ECE/TRANS/WP.29/GRPE/2007/6
31 October 2006

REVISED PROPOSAL FOR DRAFT AMENDMENTS TO REGULATION No. 110

(Specific components for CNG)

Submitted by the expert from the European Natural Gas Vehicle Association (ENGVA)

Fig. 1: 20 MPa Filling unit (receptacle) for M1 and N1 vehicles

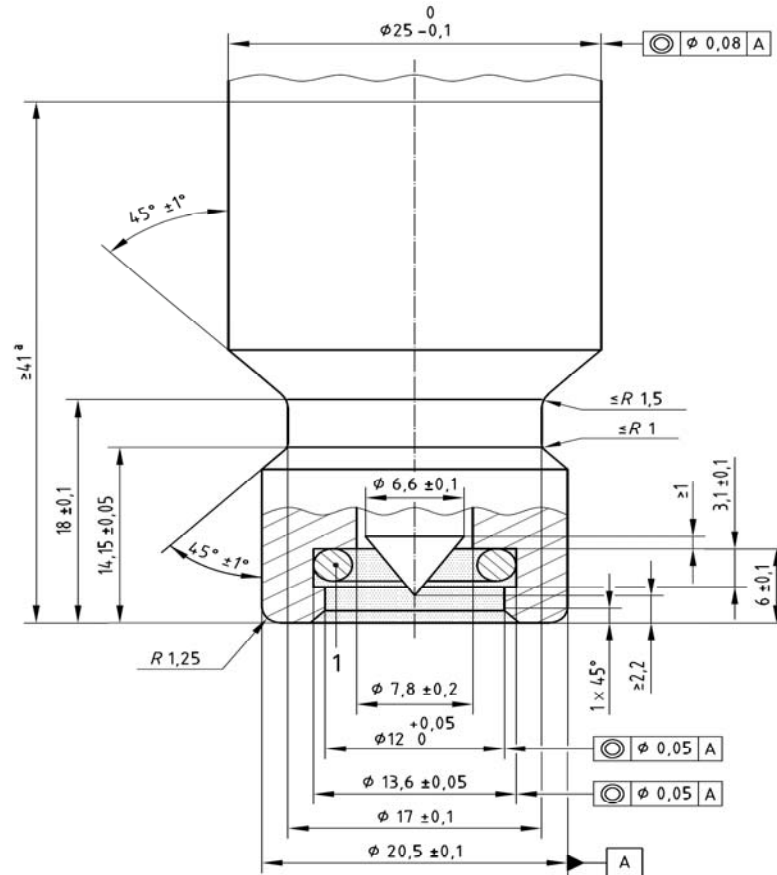
"17.9.3. For vehicles of classes M1 and N1 the filling unit (receptacle) shall comply with the drawing specifications detailed in Figure 1 of Annex 4F.

4.1. Figure 1 shows the dimensions of the filling unit for vehicles of categories M1 and N1. 2/
